CITY PLANNING COMMISSION AGENDA

**THURSDAY, JULY 16, 2015
8:30 A.M.**

CITY PLANNING COMMISSION MEETING AGENDA THURSDAY, JULY 16, 2015

**BATES
STUDENT
HOUSING
DEVELOPMENT PLAN**

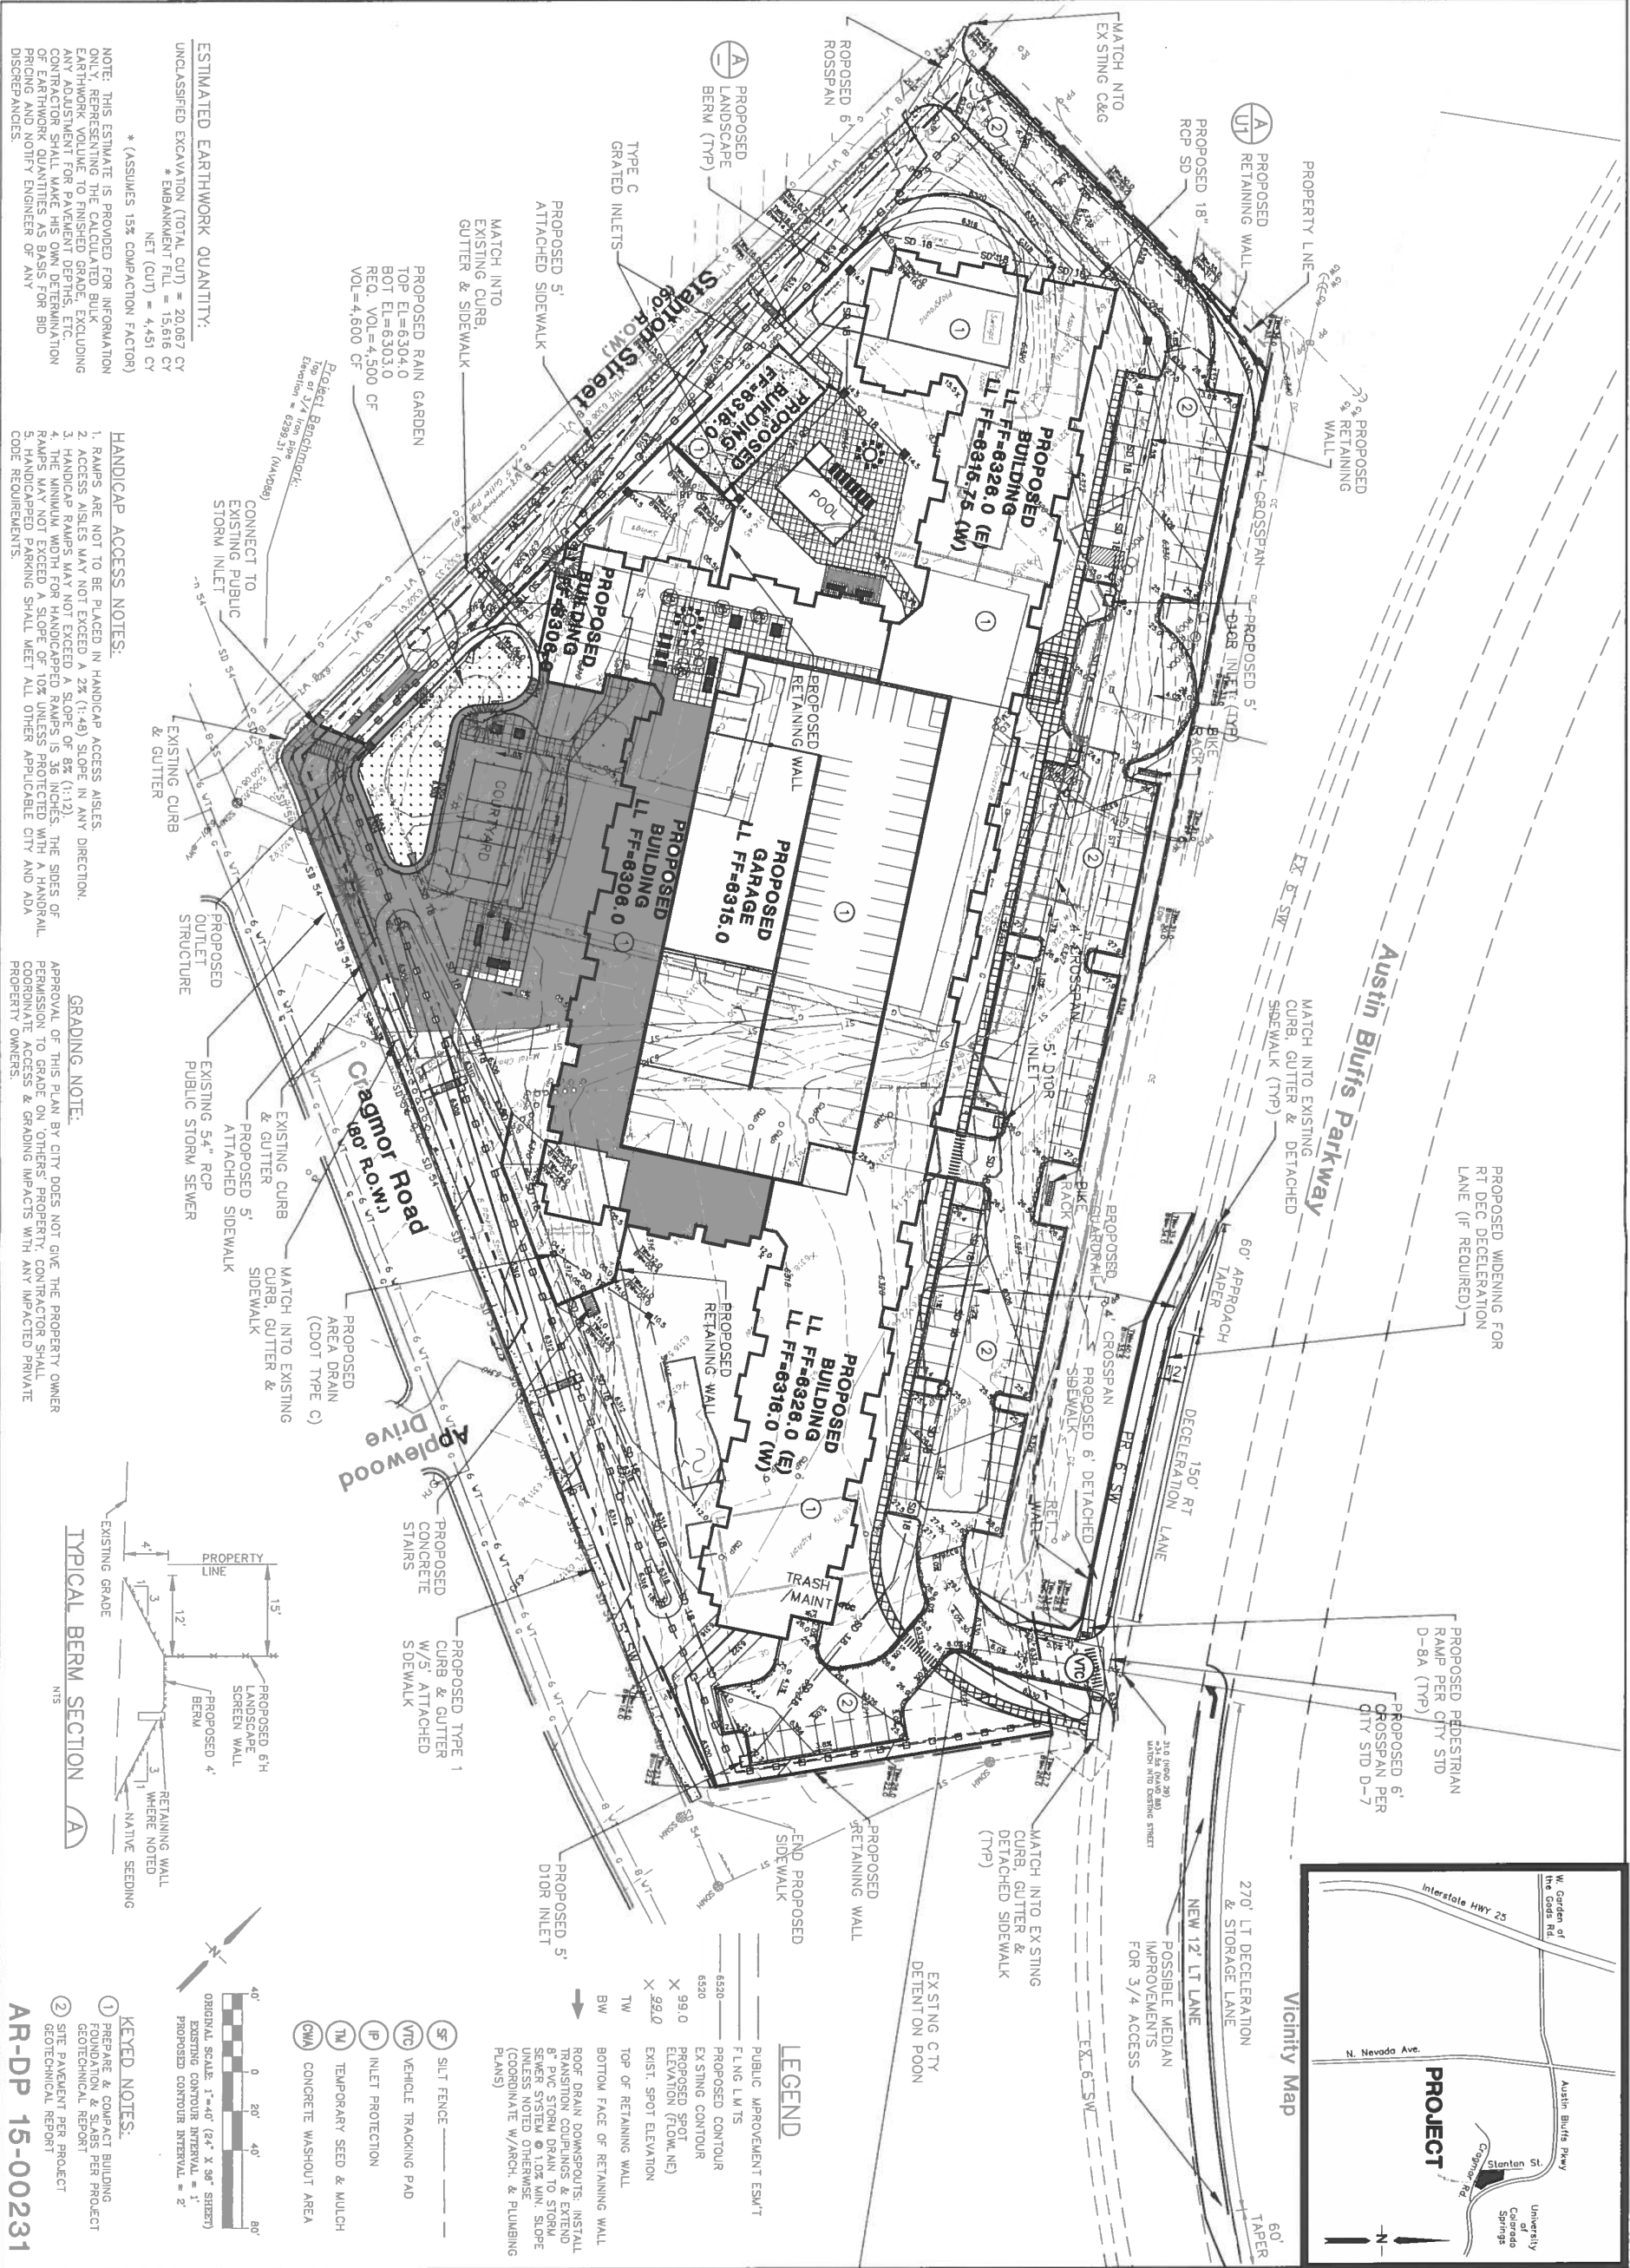
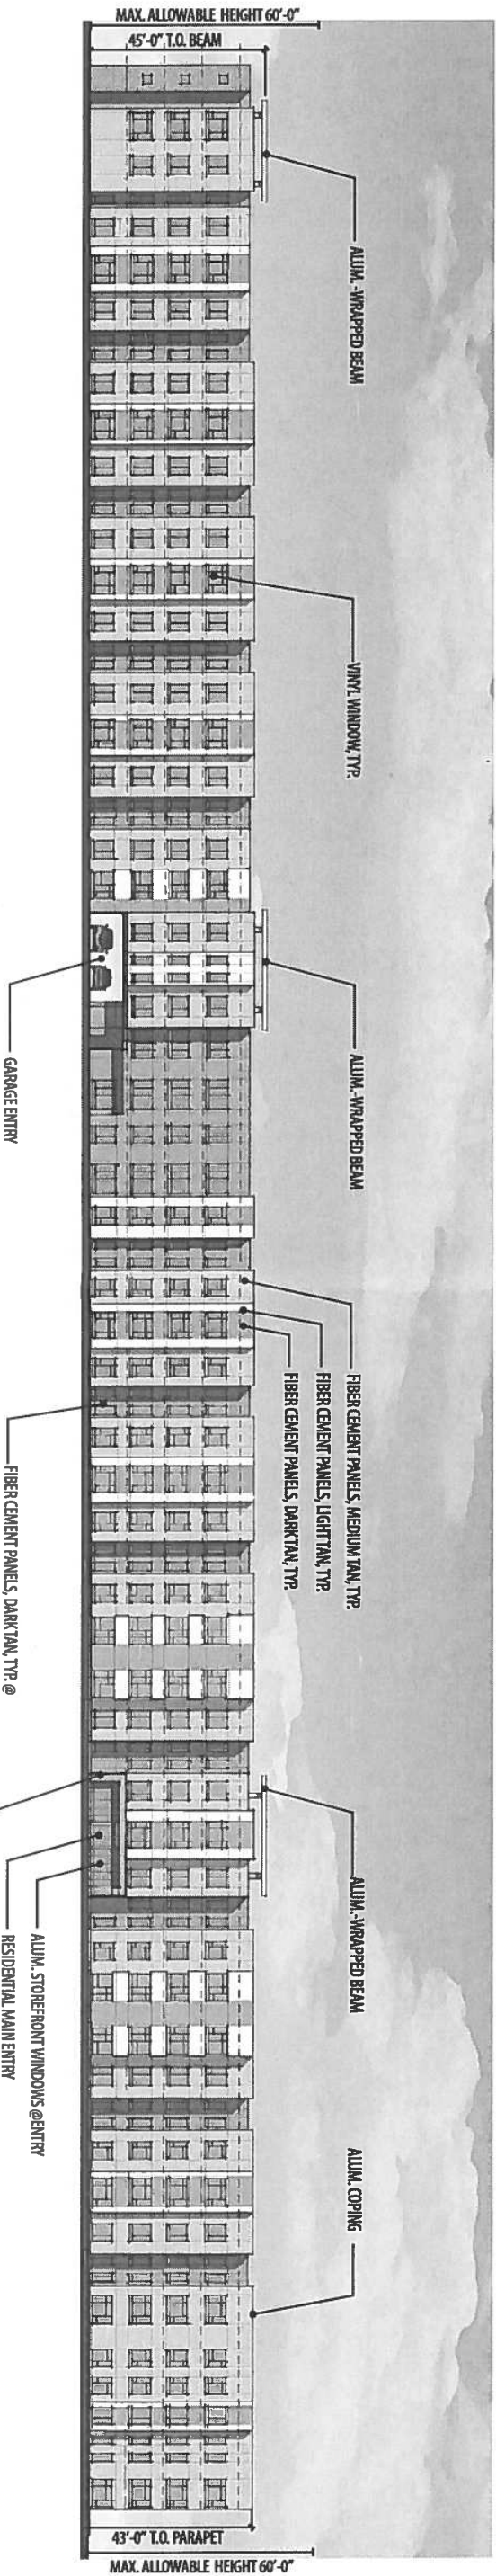
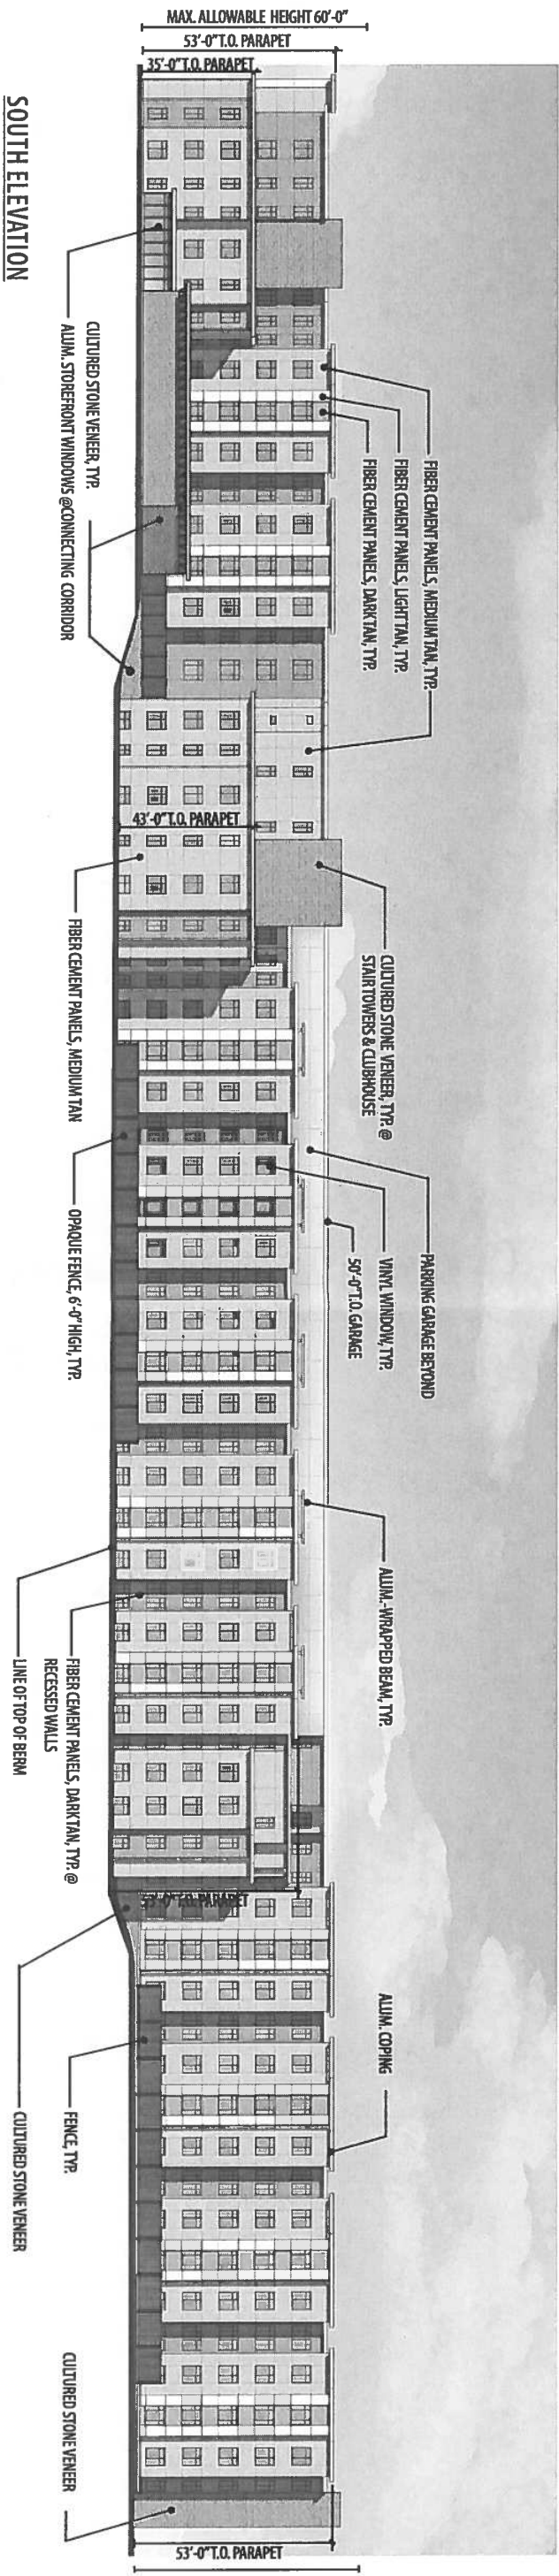
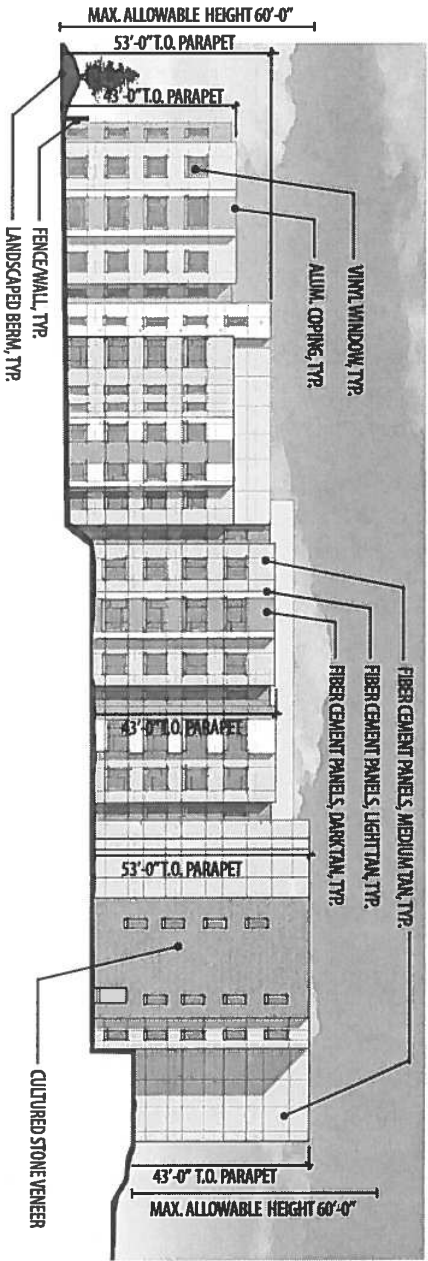
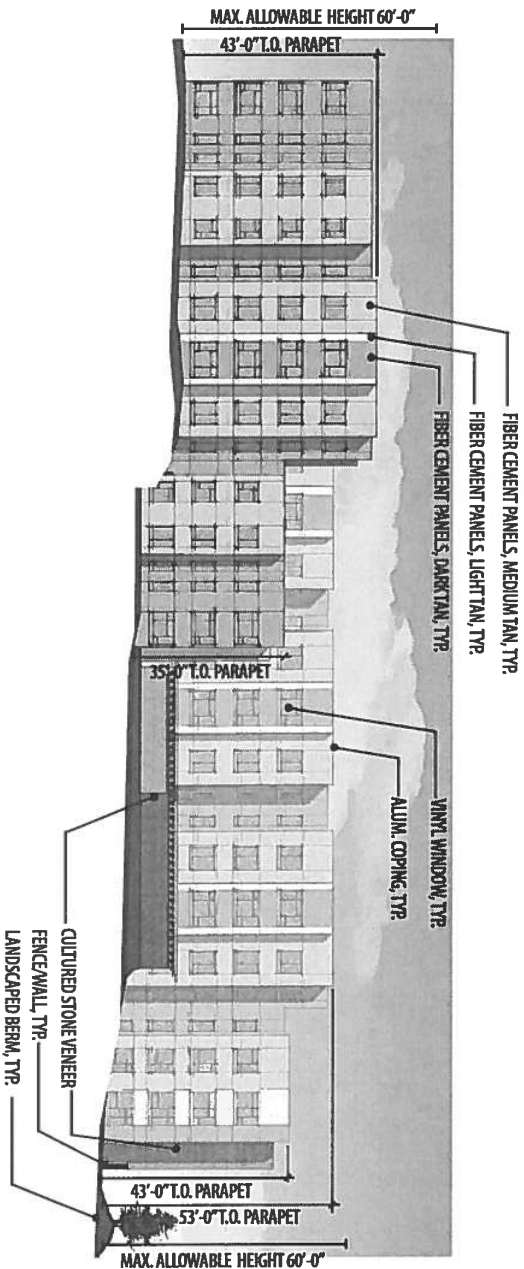
1. Call out the lumen light levels on the photometric plan.
2. Change total provided under the parking requirement section to total required.
3. Correct the 'Required' Tree Count for Cragmoor to 29 (not 39).
4. Correct the 'Required' Tree Count for Stanton to 25 (not 33).
5. Correct the Internal tree calculation to reflect 350 shrub substitutes (not 270).
